Groundwater Application Review Summary Form

Application # G- 19450

PUBLIC INTEREST REVIEW FOR GROUNDWATER APPLICATIONS

A. GENERAL INFORMATION: Applicant's Name: Legacy Valley Farms, Inc. County: LINN

Water-Level Measurements in Nearby Wells

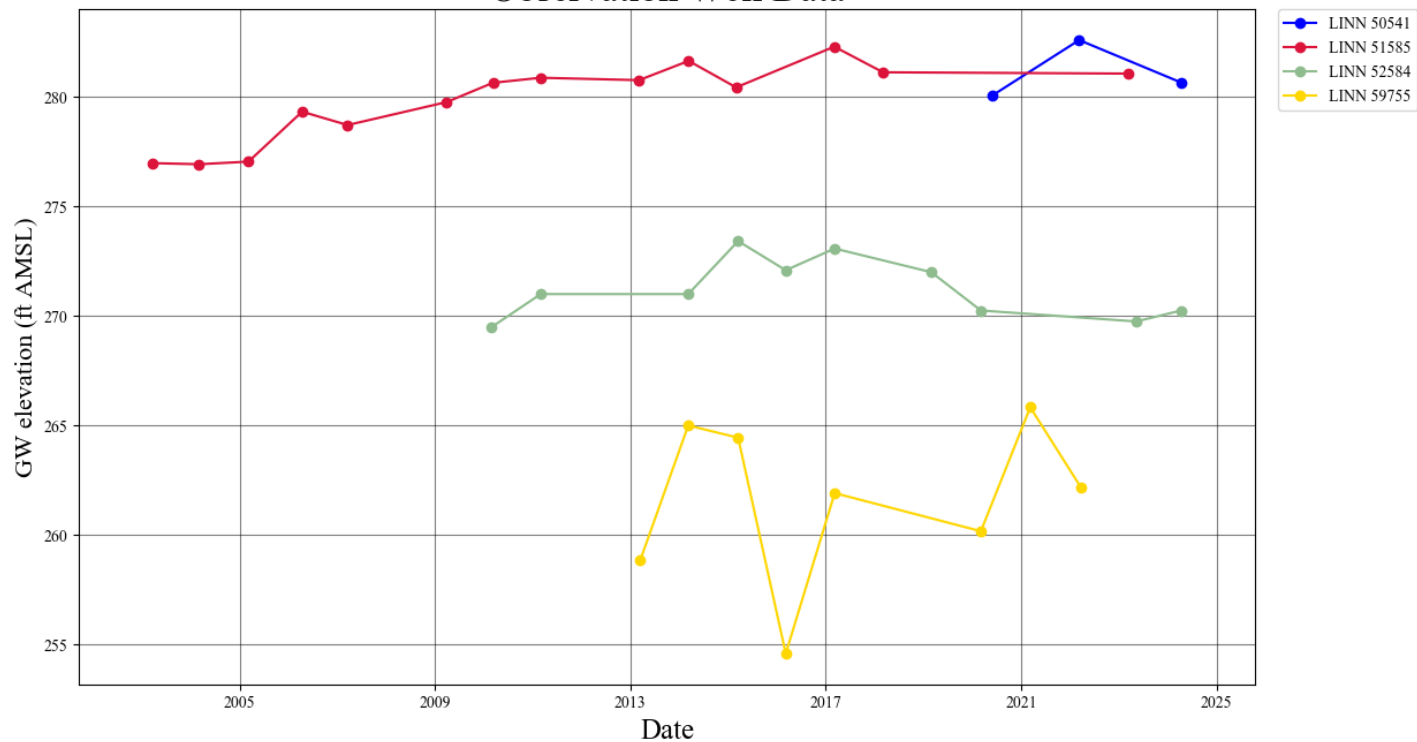
Water level measurements in nearby wells are generally stable (see attached Hydrograph). Based on these measurements and the hydrogeological conceptual model of the aquifer, the groundwater resource is not over-appropriated.

Well Statistics

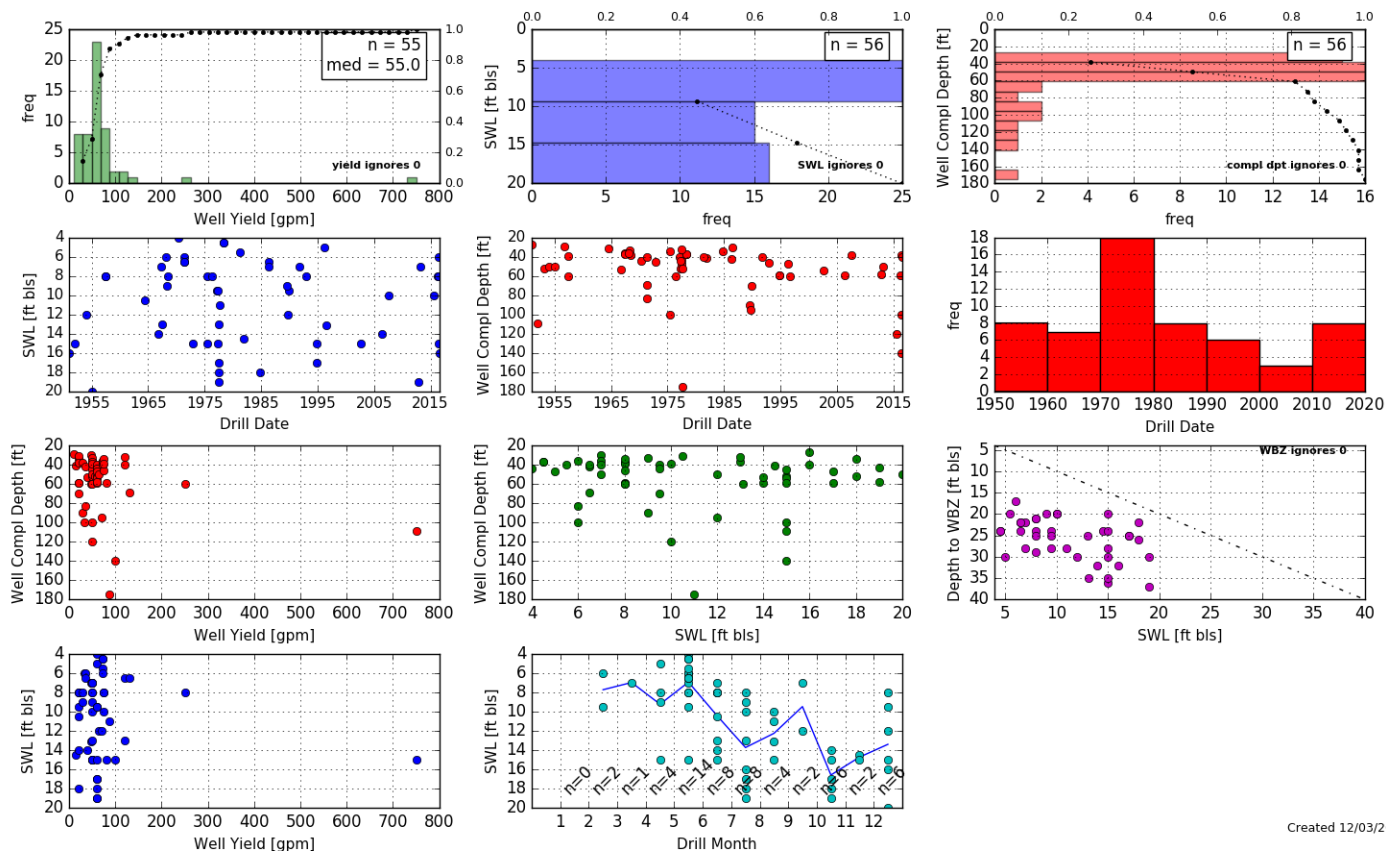
Reported yields in nearby wells range from 10-750 gpm (~0.02-1.67 cfs), with a median yield of 55 gpm (~0.12 cfs) (see attached Well Statistics). Applicant has requested well-specific rates for the proposed POA, with the highest being ~781 gpm (1.74 cfs) for proposed Well 4, which would be ~104% of the highest reported yield for any well in the area and ~1,420% of the median reported yield. **Based on the available data, the requested well-specific rate of 1.74 cfs for Well 4 is likely not achievable and, therefore, beyond the capacity of the groundwater resource.** The next highest requested well-specific rates were for proposed Wells 2 and 3, either of which would have to produce at least 1.635 cfs (~734 gpm) to achieve the combined 3.27 cfs from both wells. 1.635 cfs is ~98% of the highest reported yield for any well in the area and ~1,300% of the median reported yield. While achieving the requested rates for proposed Wells 2 and 3 may be difficult, it does at least appear to be possible. Therefore, the requested rates for proposed Wells 2 and 3 – as well as existing Well 1 – are within the capacity of the groundwater resource.

Well 3 to LINN 13793

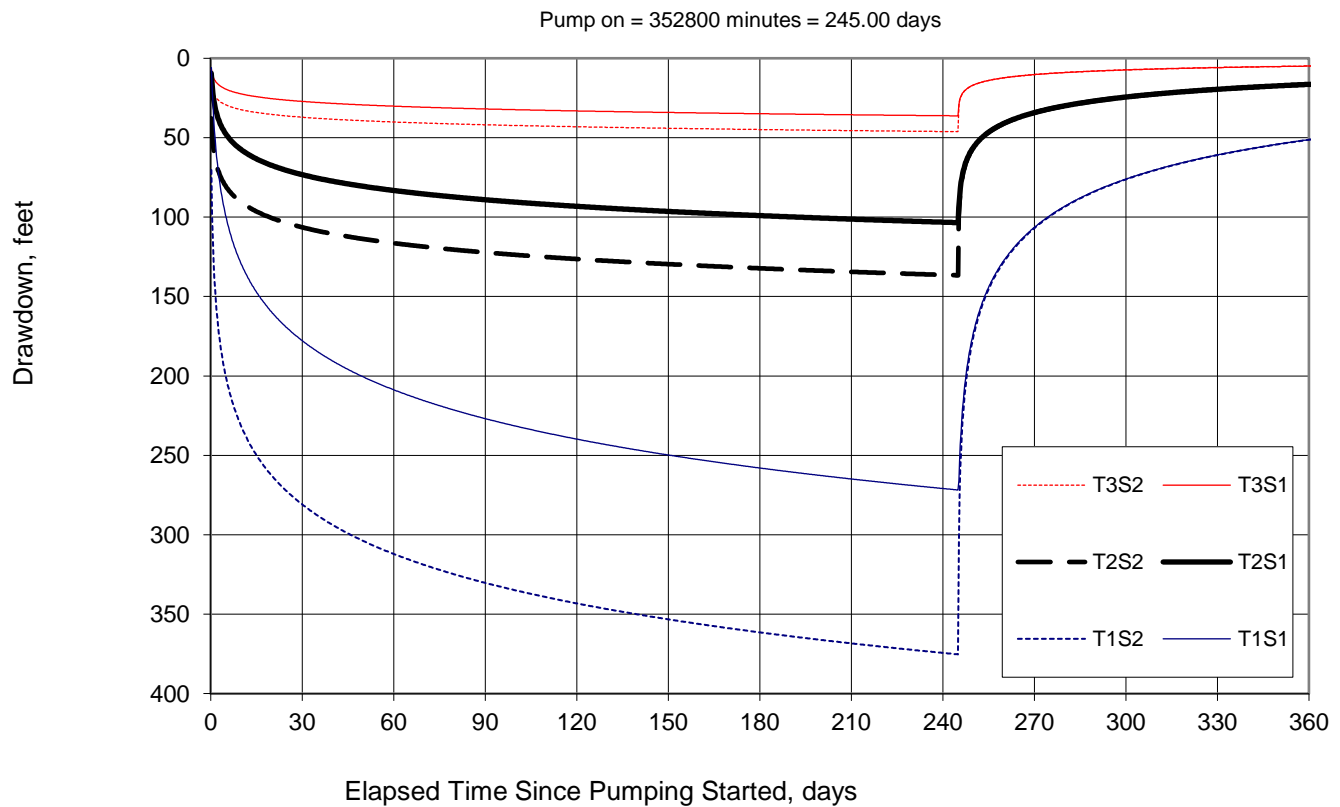
The nearest wells to the proposed POA are: LINN 13793, a domestic well, ~330 ft southwest of proposed Well 3; LINN 13815, a domestic well correlated to Tax Lot 800, ~1,200 ft northwest of proposed Well 4; and LINN 13779, an irrigation well, ~1,900 ft northwest of Well 1 (LINN 13774) and ~2,100 ft northwest of proposed Well 2. Potential interference with neighboring wells due to the proposed use was analyzed using the Theis (1935) solution for drawdown in a confined aquifer (see attached Well-to-Well Interference Analyses). Results of the analyses indicate that, at a rate of 1.635 cfs, Well 3 is very

likely to exceed 25 ft of interference with neighboring LINN 13793 within several weeks of pumping, which would then require curtailment under the standard permit conditions for new alluvial groundwater rights. **As such, the proposed use of Well 3 is not within the capacity of the resource. Furthermore, at a rate of 1.635 cfs, proposed Well 3 would likely cause injury to LINN 13793 before the end of the irrigation season.** Well 4, at its maximum requested rate of 1.74 cfs, would very likely exceed 25 ft of interference with neighboring LINN 13815 within several weeks of pumping, which would then require curtailment under the standard permit conditions for new alluvial groundwater rights. **As such, the proposed use of Well 4 is not within the capacity of the resource.** Although the proposed use of Well 4 would also likely lower water levels below the shallow bottom of LINN 13815, the level of interference would not likely injure LINN 13815 if it fully penetrated the aquifer. Well 2, at a rate of 1.635 cfs would likely exceed 25 ft of interference with neighboring LINN 13779 within ~2.5 months of pumping, which would then require curtailment under the standard permit conditions for new alluvial groundwater rights. **As such, the proposed use of Well 2 is not within the capacity of the resource.**
